**16C1 TELEGRAPH REPEATER
AND BALANCED LOOP APPLIQUE**

1.001 This addendum to Section 312-304-100, Issue 1 is issued to replace Figures 12, 13 and 14 with revised Figures 12, 13 and 14.

Revised Fig. 12—Differential Duplex Battery and Line Normal

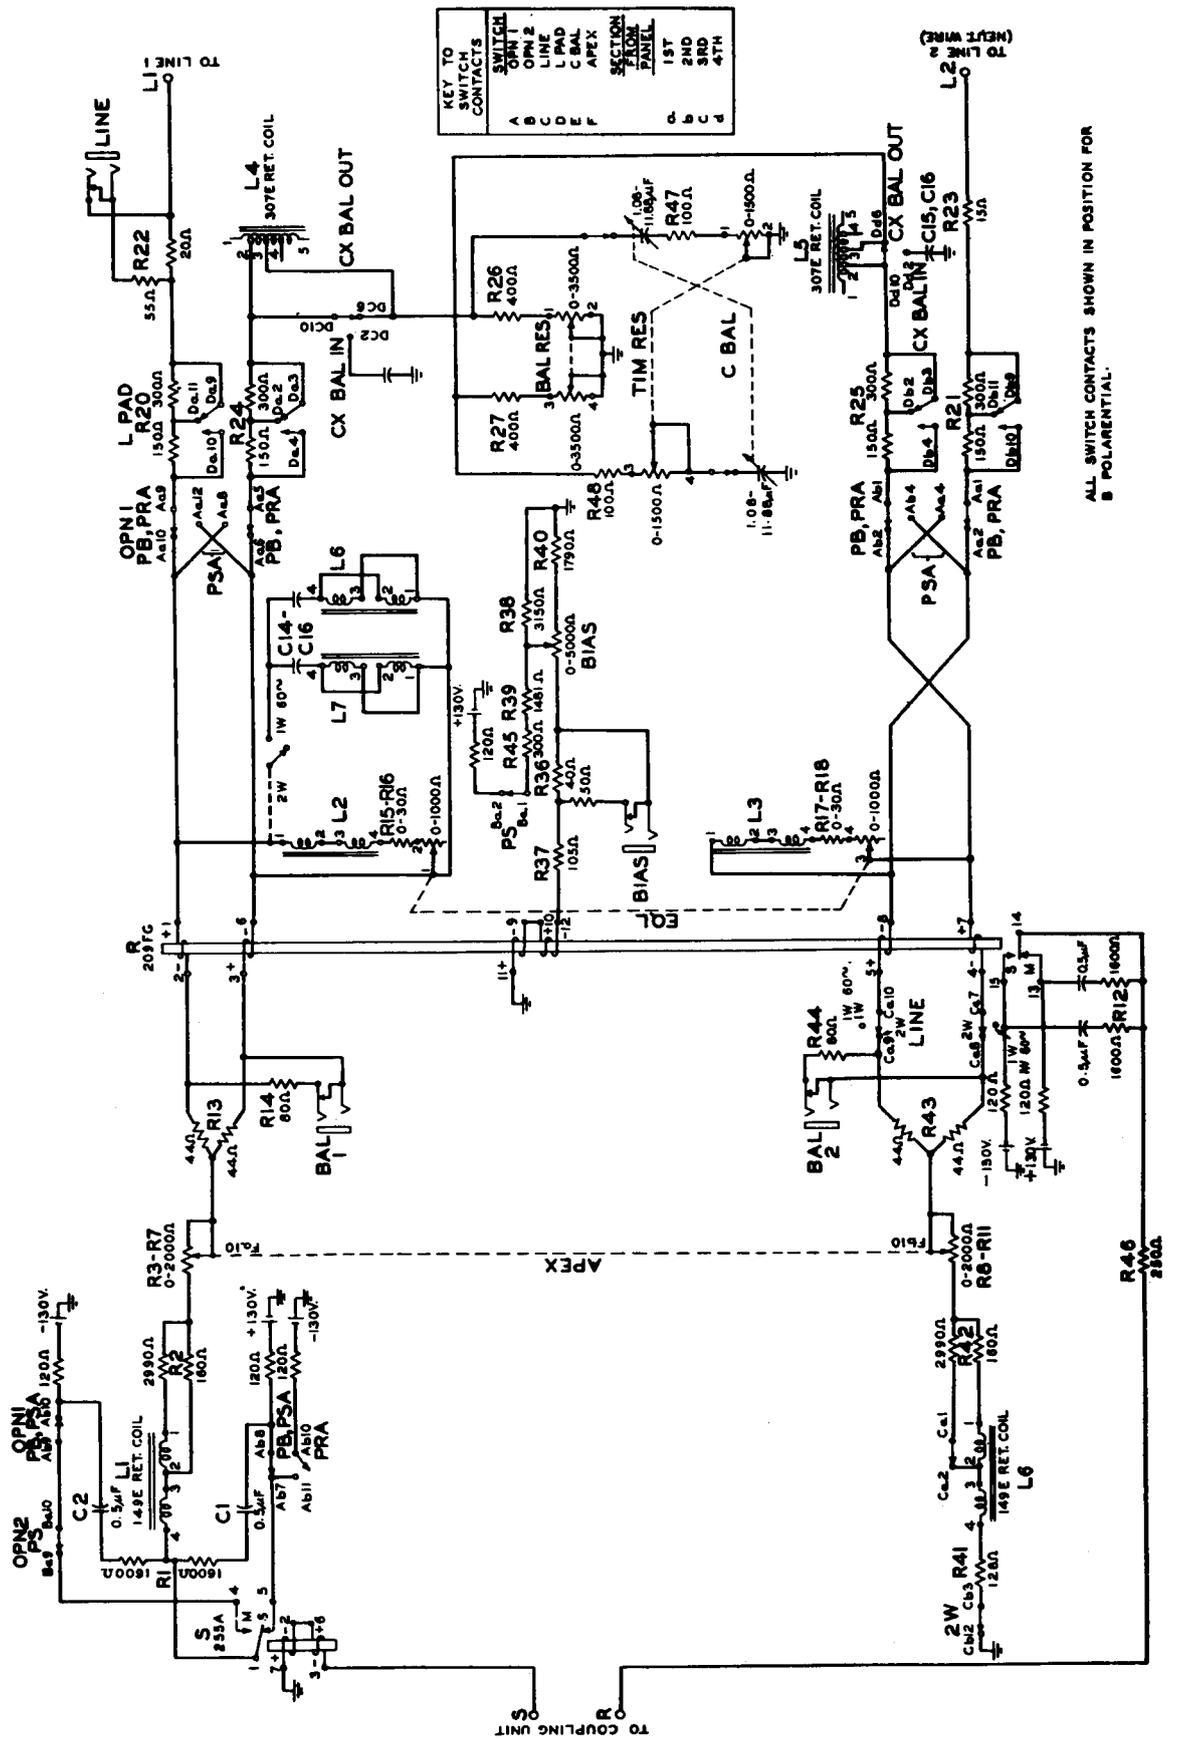
1.002 The changes made in Figures 12, 13 and 14 rectify errors in the previous issue. The spacing polarity on the R lead to the coupling unit is changed from +130 volts to -130 volts and the marking voltage from -130 volts to +130 volts.
